**VIRGINIA ELECTRIC AND POWER COMPANY
(DOMINION ENERGY VIRGINIA)
NORTH ANNA POWER STATION UNITS 1 AND 2
SURRY POWER STATION UNITS 1 AND 2**

Response to Request for Additional Information

Proposed Consolidate Emergency Operations Facility License Amendment Request

MARKED-UP NAPS EMERGENCY PLAN CHANGES

CORPORATE EMERGENCY RESPONSE CENTER ORGANIZATION

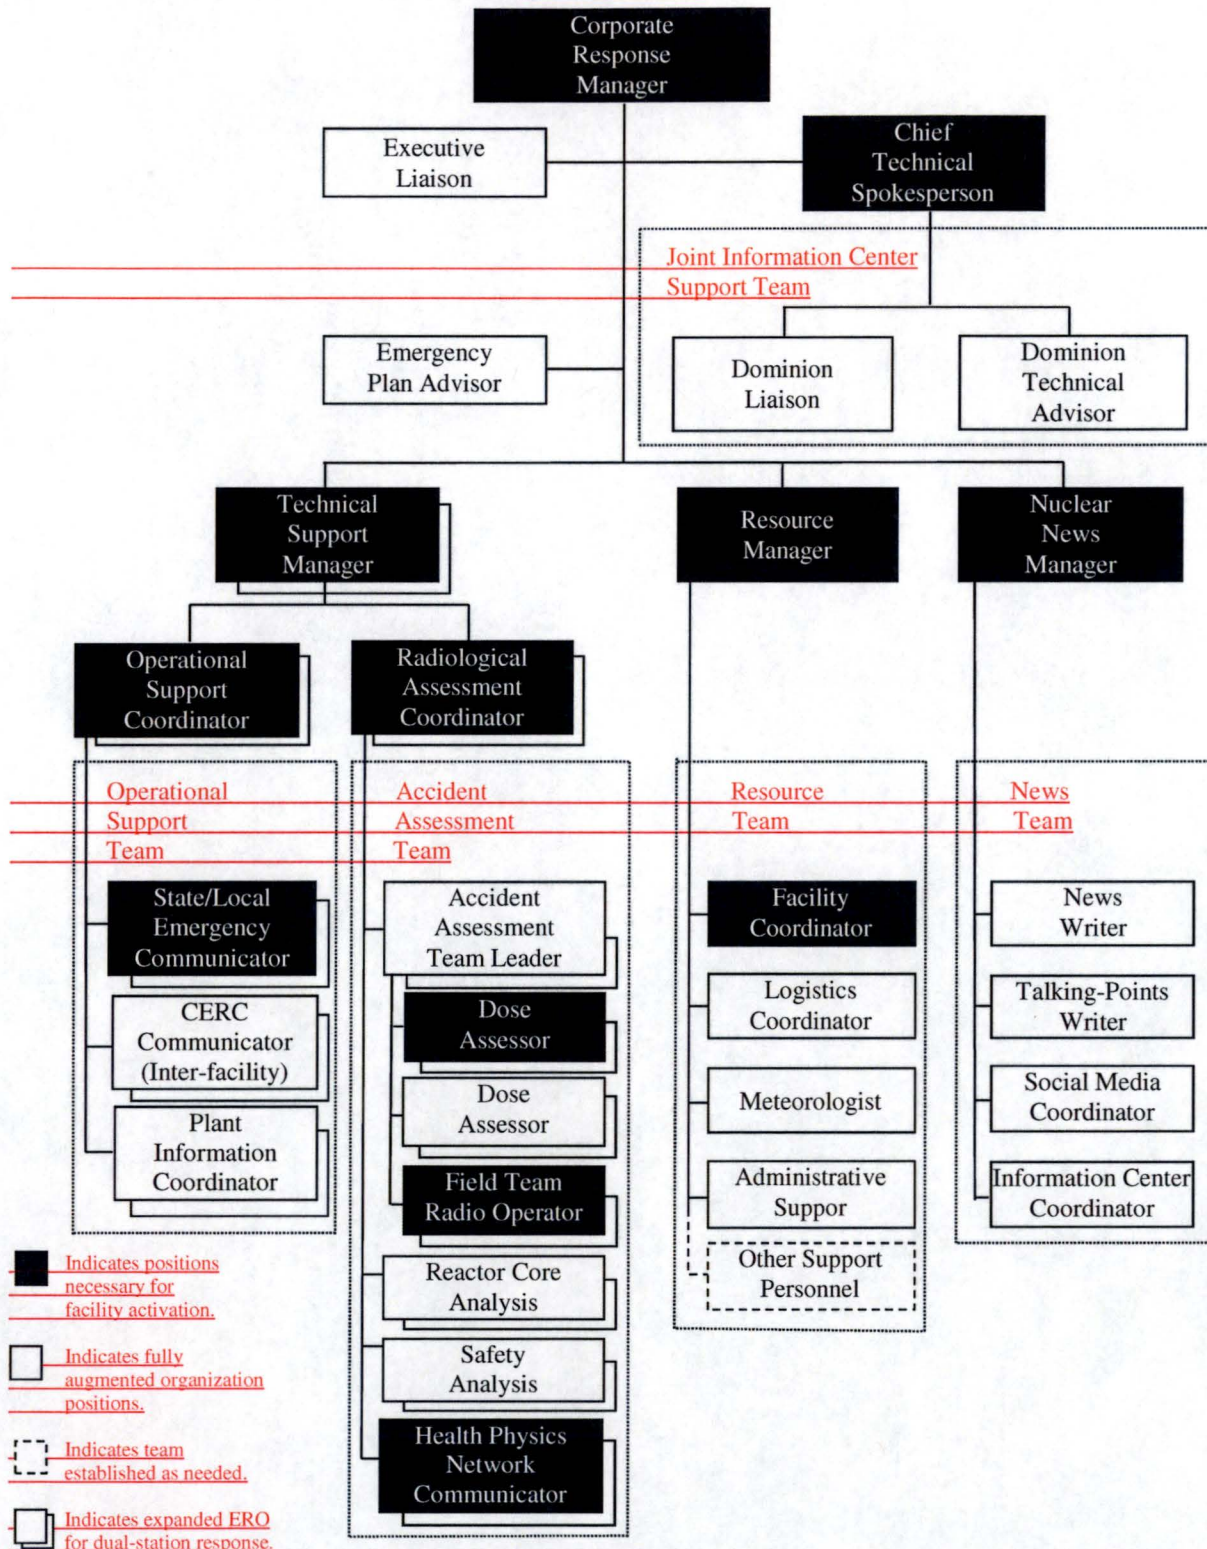
* Offsite Monitoring Teams are controlled by CERC Accident Assessment Team after being staged.
